Report to Committee

RZ 17-768762

Application by Landcraft Homes Ltd. for Rezoning at 5751 Francis Road from

"Single Detached (RS1/E)" Zone to "Arterial Road Three-Unit Dwellings (RTA)"

2 NORTH ELEVATION

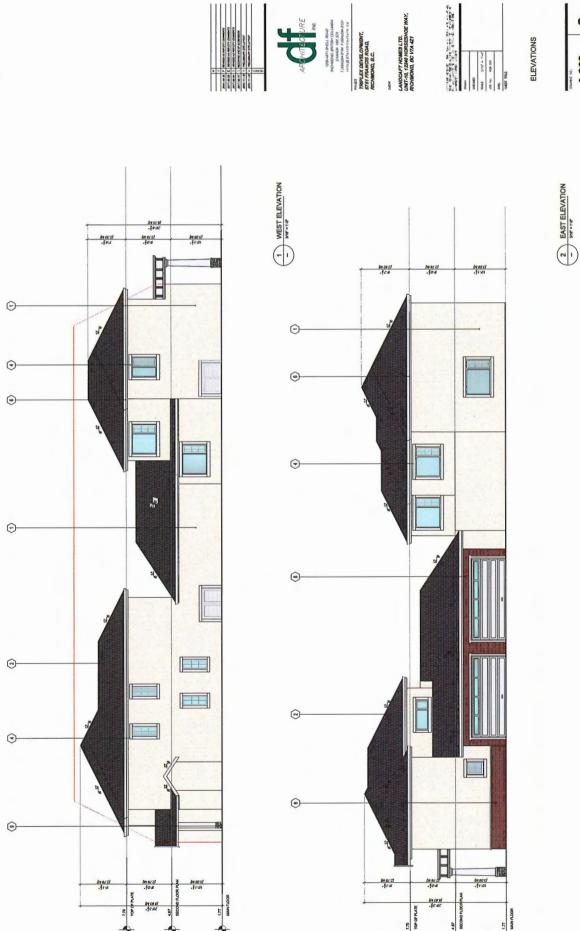
- Design development is required on the west elevation to provide additional articulation on the elevation that is exposed to the parking area of the adjacent assembly site.
- Design development is required to provide additional private open space for the street fronting unit, outside of the front yard along the arterial road.
- Review of aging-in-place features in all units and the provision of a convertible unit
- Refinement of the proposed site grading to provide appropriate transition between the proposed development and adjacent existing developments.
- Refinement of landscape design, including the location and type of fence proposed within the front yard, and the provision of a holding area or an enclosure for garbage/recycling material storage/collection.

1 SITE PLAN

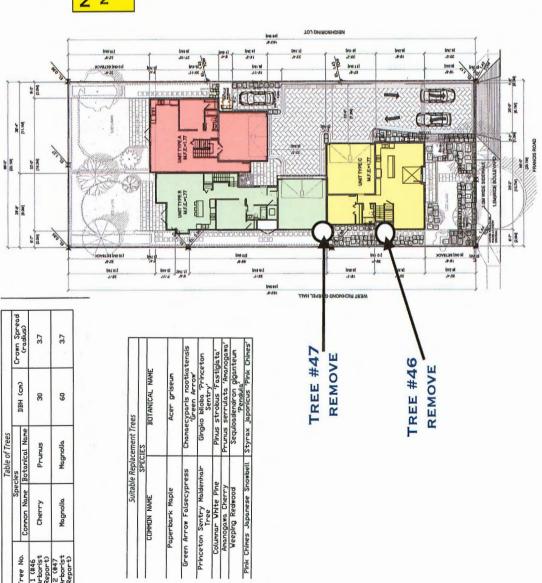
- Two trees located on site, specifically tag# 46 (12" dia Cherry) and tag #47 (Multi-branching Magnolia) have been repeatedly pruned for a compact form and as a result display low vigor. These trees should be removed and replaced.
- Replacement trees should be specified at 2:1 ratio as per the Official Community Plan (OCP).

The developer wishes to remove two on-site trees. The 2:1 replacement ratio would require a total of four replacement trees. According to the Preliminary Landscape Plan provided by the developer (Attachment 2), the developer is proposing to plant 10 trees on site. The size and species of replacement trees will be reviewed in detail through Development Permit and overall landscape design.
